Amendments to the Drawings:

REMARKS

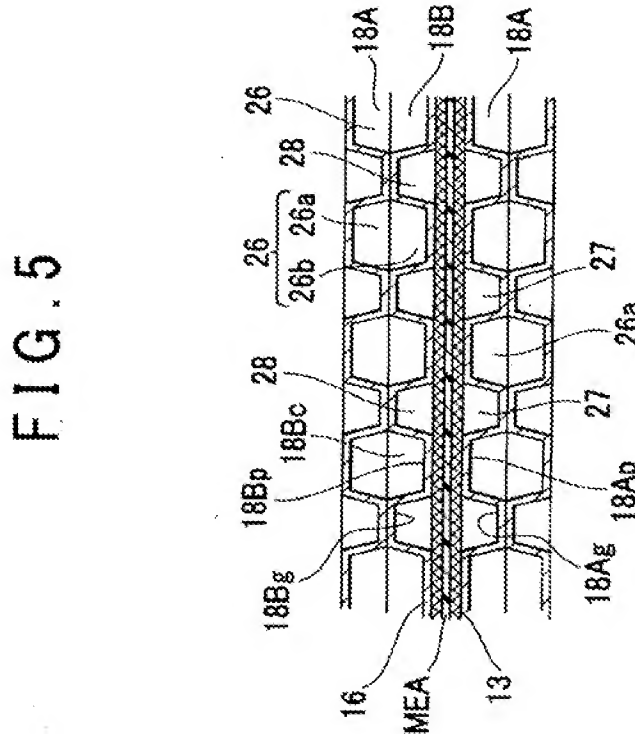
The drawings are objected to as failing to comply with 37 CFR 1.84(p)(5) because they do not include reference signs as mentioned in the description. Withdrawal of these objections is respectfully requested in light of the attached Replacement Drawing Sheets for FIGS. 3, 4, and 7.

Claims 2-9 and 11-18 are rejected under 35 U.S.C. 112, second paragraph, as being indefinite for failing to particularly point out and distinctly claim the subject matter. More specifically they were objected to for the use of the terms “concave groove” and “convex rib” in the claims.

The attached sheet of drawings includes changes to FIGS. 3, 4, and 7. These sheets, which include FIGS. 3, 4, and 7, replace the original sheets including FIGS. 3, 4, and 7. In these figures, previously omitted reference numerals are added.

As seen in FIG. 5, reference numeral 18Ag, indicative of the concave groove, is curved away from the MEA. In contrast, reference numeral 18Ap, the convex rib, is curved towards the MEA. FIG. 5 is consistent with FIG. 4, where reference numeral 18Ag is also curved away from the MEA. Therefore, the Applicant respectfully requests reconsideration and removal of the 35 U.S.C. 112, second paragraph rejection.
